Planning and Land Use Committee Report

Subject: Development Permit Application with Variances #000368 for 1014 Park Boulevard

1014 Park Boulevard
Development Permit #000368

Re: Development Permit Application with Variances for 1014 Park Boulevard

ELEVATIONS

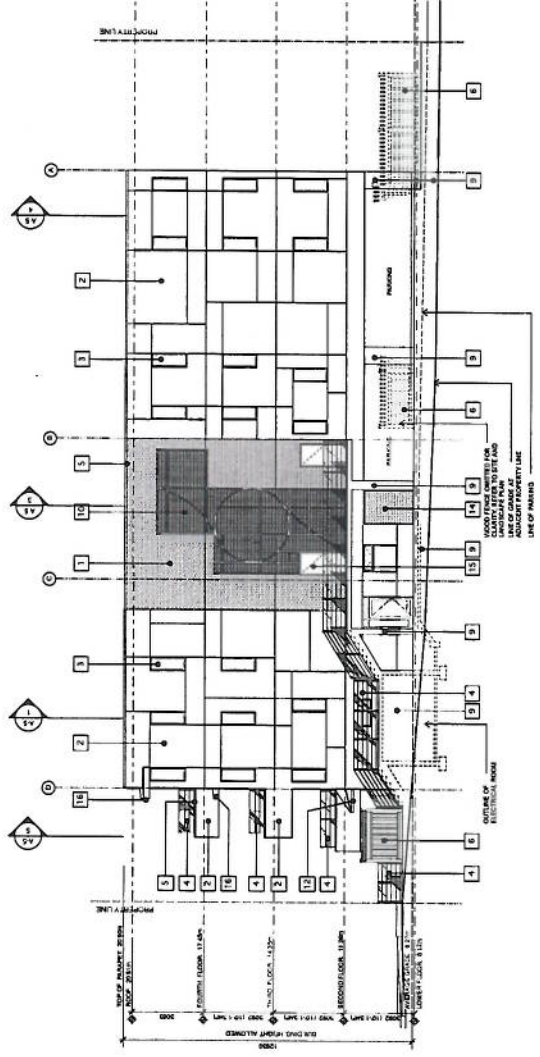
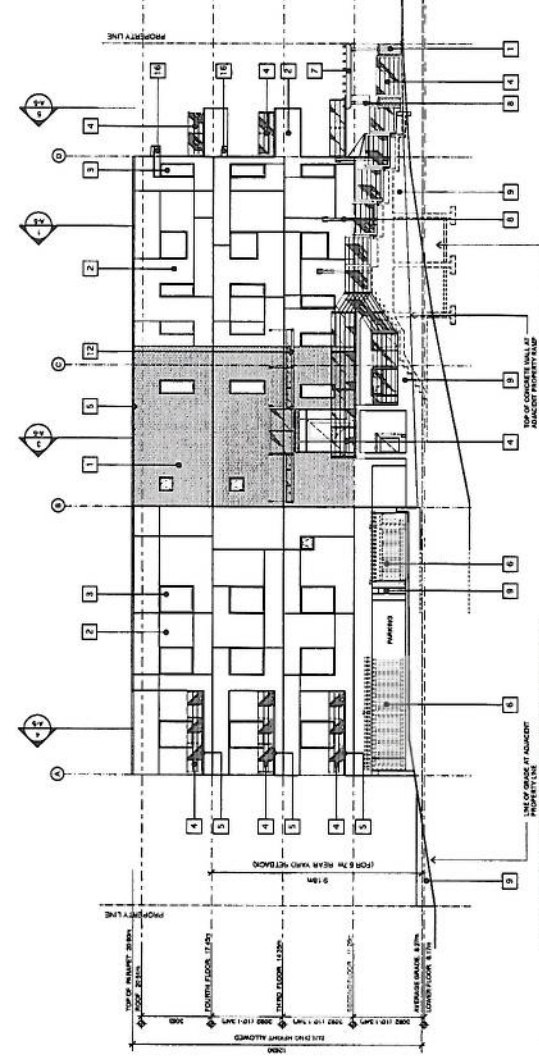
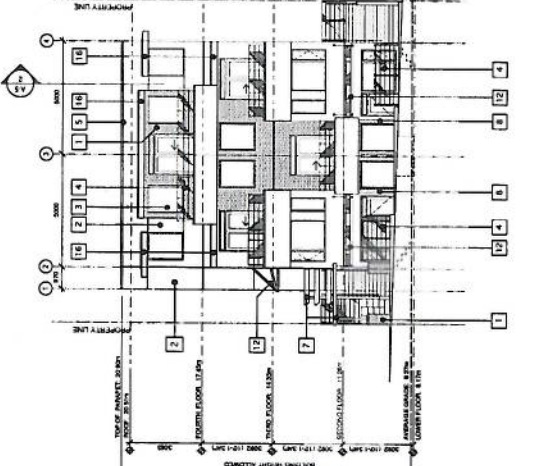
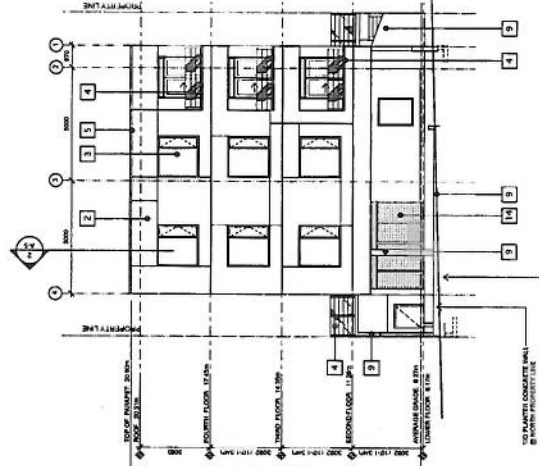
We are requesting a variance of 1.5m to the rear yard setback for the portion of the building that is above 9.18m. The rear yard setback for the portion of the building below 9.18m, or for the first three floors, is remaining as already approved at 5.70m; however, in order to respond to the market demands we have had to revise the floorplans of the units. In doing so, the location of the balcony on the fourth floor for the north facing unit has been relocated to maintain a consistent structural design from the fourth floor to the second floor. It is important to note that the overall building is not any closer to the laneway than previously approved; it is only the fourth floor that has been moved to line up with the floors below.

Through completing the working drawings for the building, both the floor system and the roof structure being used are thicker than what was assumed when the schematic design was completed. The floor system is 0.044m thicker per floor and the roof system including the parapet is 0.398m thicker, resulting in a total variance 0.530m. The previous building height was 12.10m, and the proposed building height is 12.63m.
